ITB14-008a

VOLUNTARY SERVICE CAMPAIGN 2014 Q50; DIRECT ADAPTIVE STEERING SYSTEM CONTROL MODULE REPLACE, REPROGRAM, AND RECALIBRATE

The Claims Information and Figure R1 in this bulletin have been amended. No other changes have been made.
Please discard previous versions of this bulletin.

CAMPAIGN ID #: P4203

Figure R1

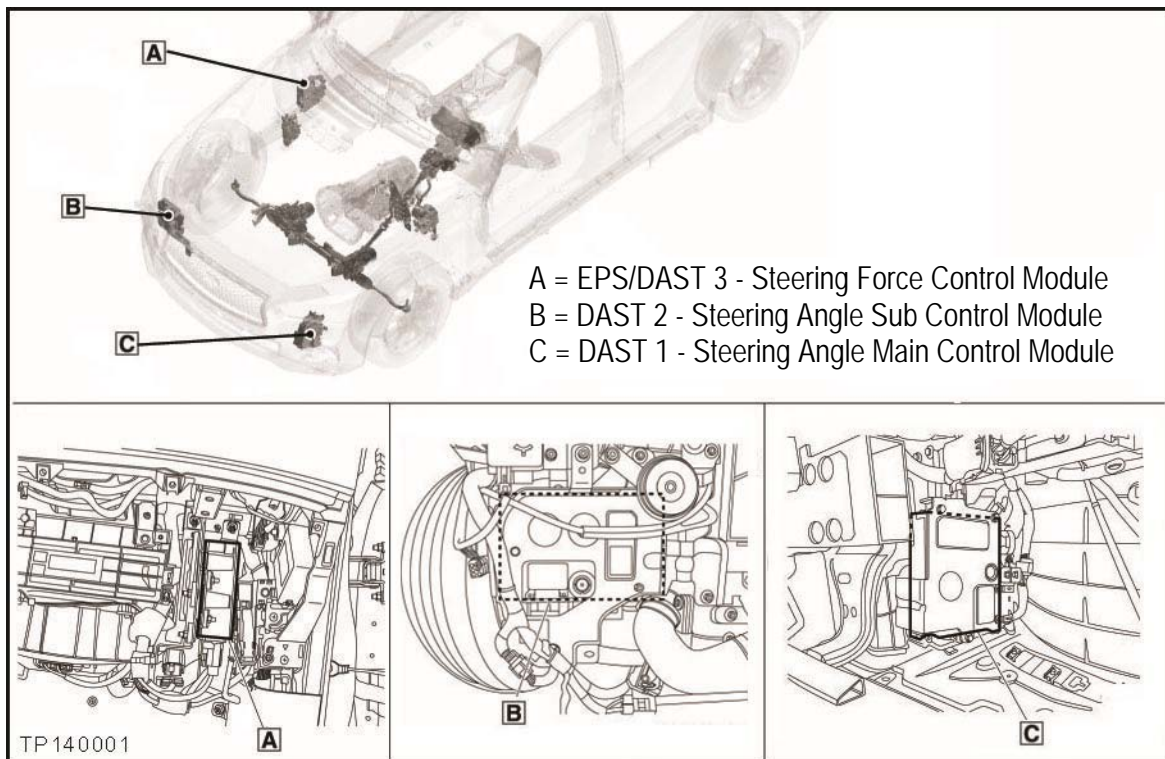
1. Replace all three DAST Control Modules (see Figure R1):

DAST 1 - Steering Angle Main Control Module.

DAST 2 - Steering Angle Sub Control Module.

EPS/DAST 3 - Steering Force Control Module.
